DEPARTMENT OF THE AIR FORCE  
HEADQUARTERS 377TH AIR BASE WING (AFMC)

1. Addendum to Final Interim Measures Work Plan (Shaw 2011)
2. Total Vapor VOC Plume Footprints
3. SVE Well Construction Diagram

**Subject: Soil Vapor Extraction Well Design, Location, and Installation  
Interim Measures Work Plan, Bulk Fuels Facility Spill, Solid Waste Management  
Units ST-106 and SS-111  
Addendum November 2011  
Albuquerque, New Mexico**

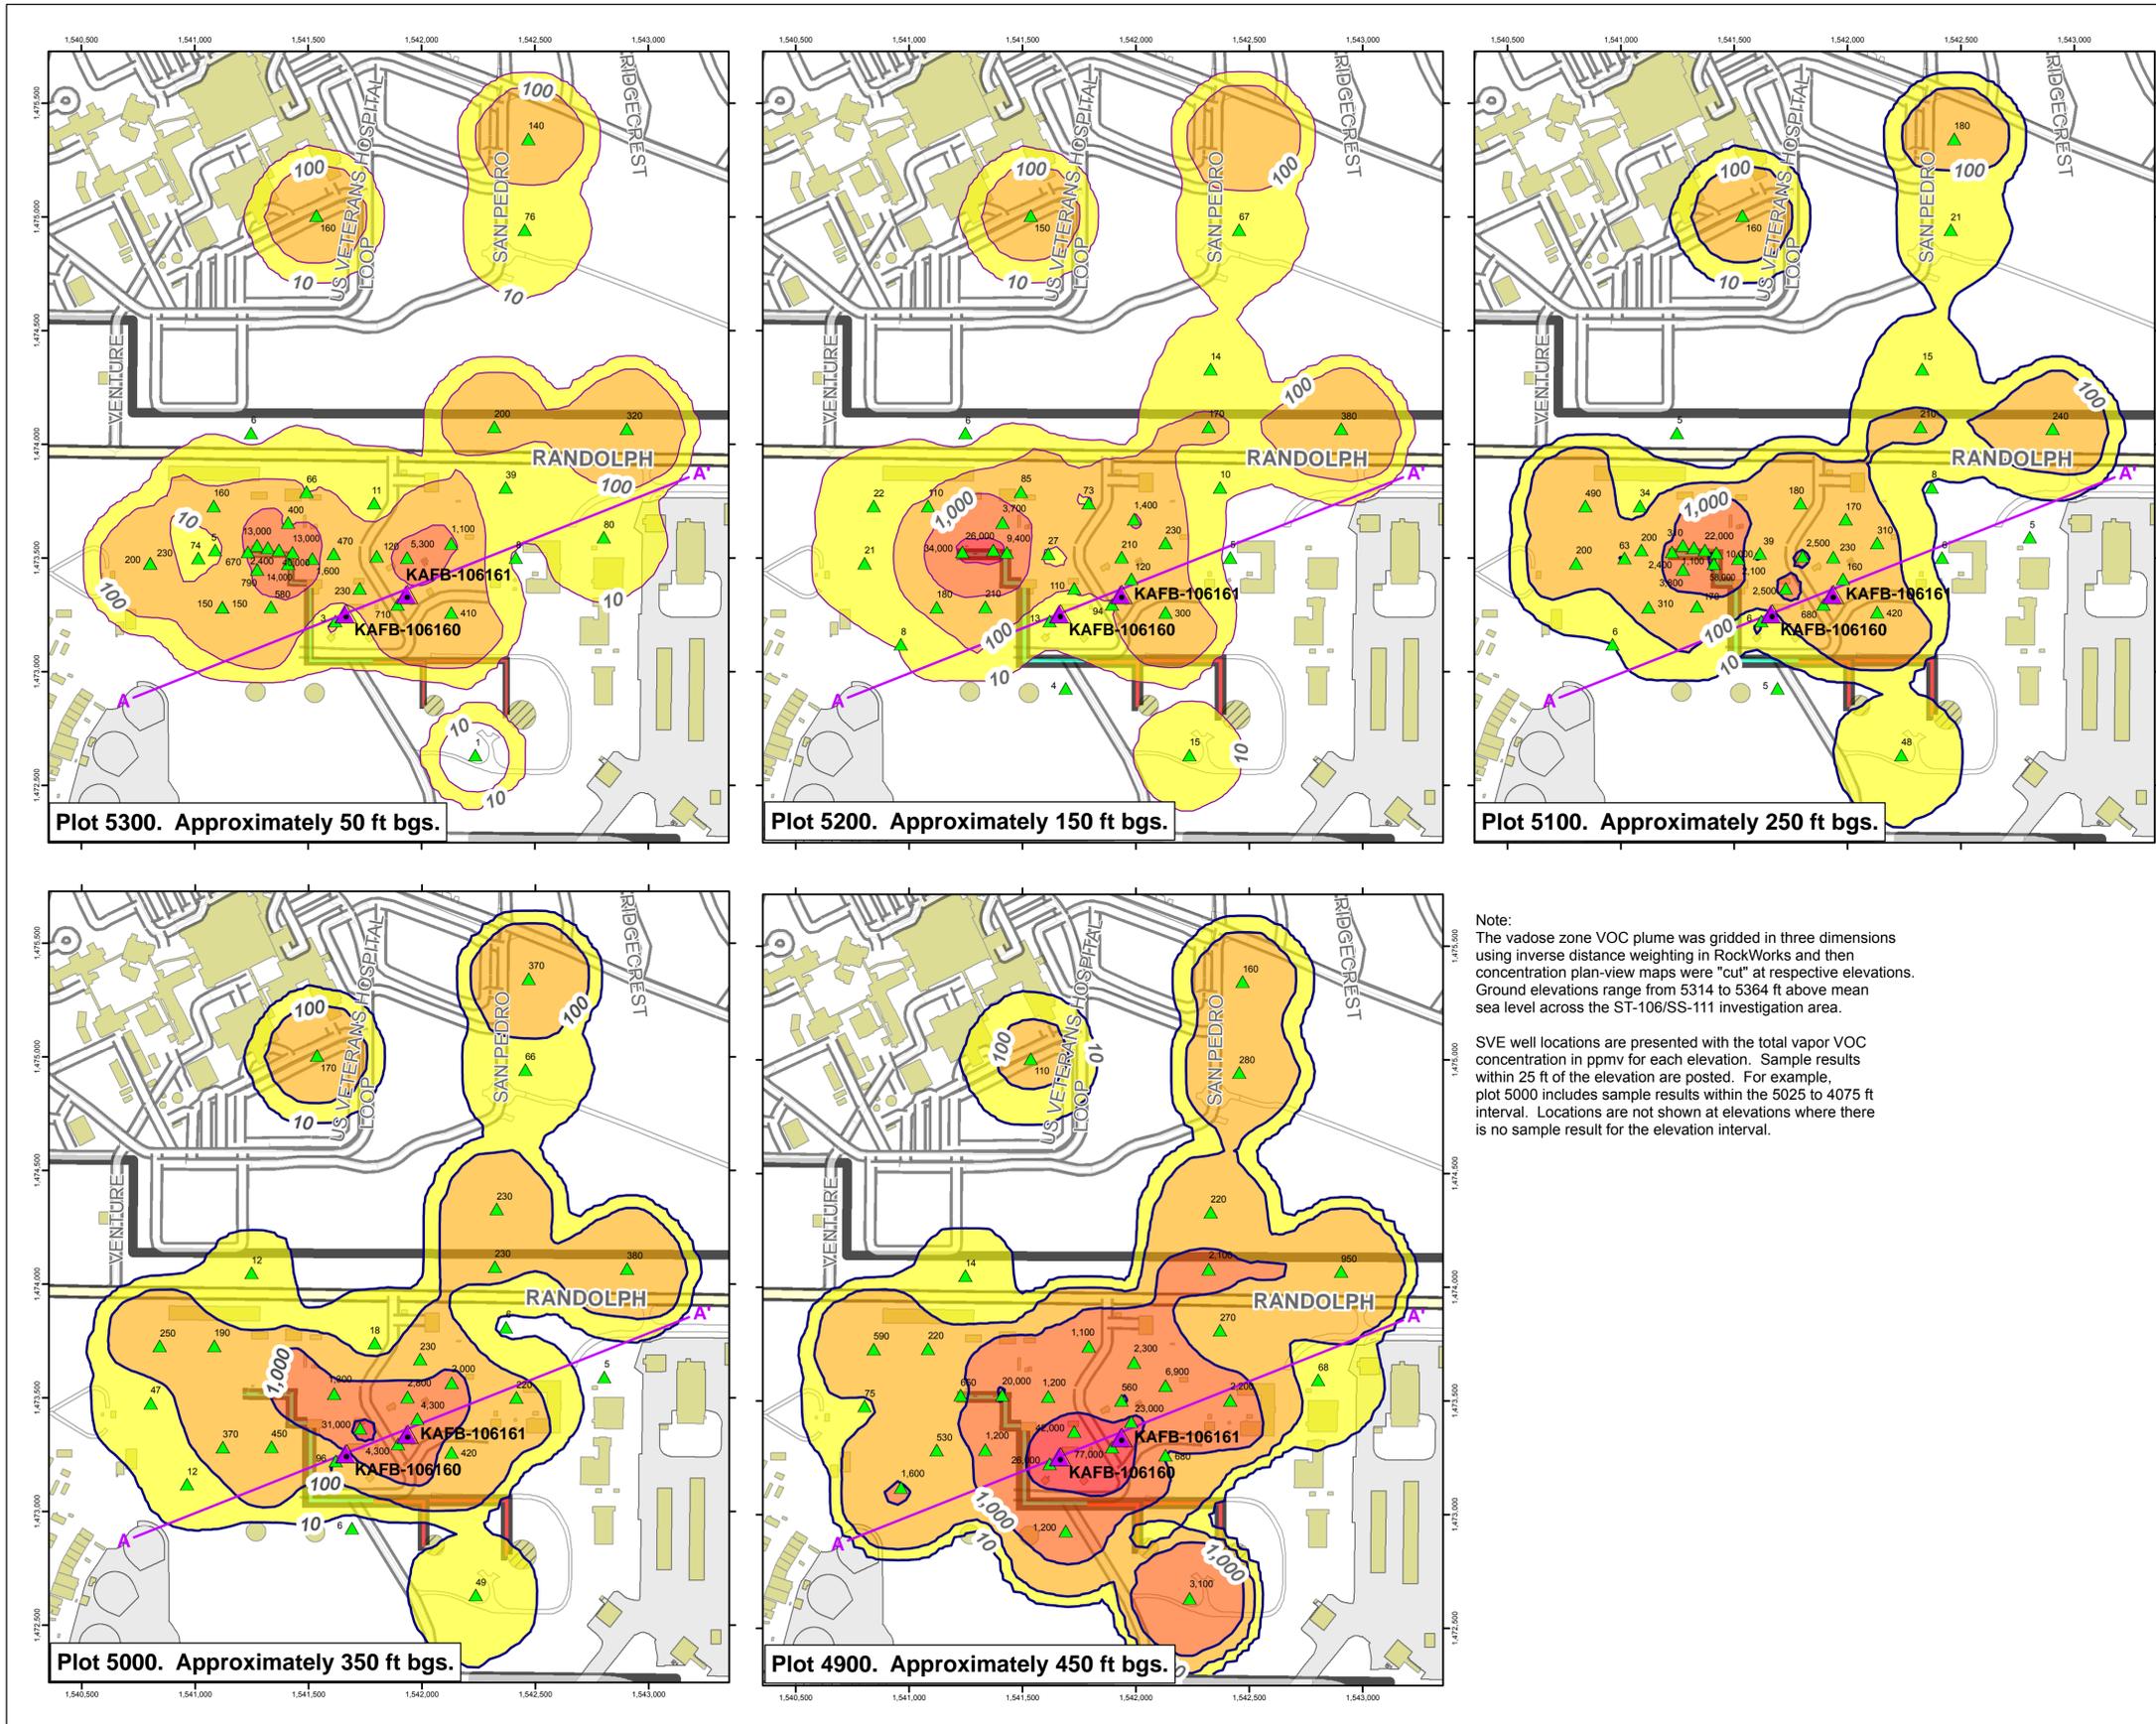
Two SVE wells with screen intervals across the water table will be installed. Each SVE well will consist of a single borehole drilling to an approximate depth of 530 feet bgs with each borehole containing a single well casing. The well casing will be 6-inches in diameter, welded, Schedule 40 steel casing. Each well will contain a 50-foot section of 0.050-inch slot, stainless steel wire-wrapped screen followed by a 10-foot section of Schedule 40 stainless steel casing connected to a 40-foot section of 0.050-inch slot, stainless steel wire-wrapped screen. Below the water table, there will be a section of 0.030-inch slot, stainless steel wire-wrapped screen. The well will be completed with a 5-foot sump at the bottom of the well. Figure 2 is a schematic diagram of SVE well construction.

**FIGURE 1  
 LAB TOTAL VAPOR VOC PLUME  
 FOOTPRINTS BY ELEVATION  
 JUNE 2011**

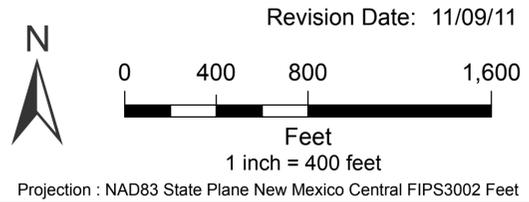
Figure 1, attached to this letter, shows the proposed locations of the two SVE wells, KAFB-106160 and KAFB-106161. Both wells are located on the installation and are within the region showing the highest concentration of vapor based on the results of Quarter 2 (April – June) 2011 data (Figure 1). The spacing of the wells is based on the vapor results, as well as a preliminary understanding of the radius of influence for soil vapor extraction units screened in the vadose zone.
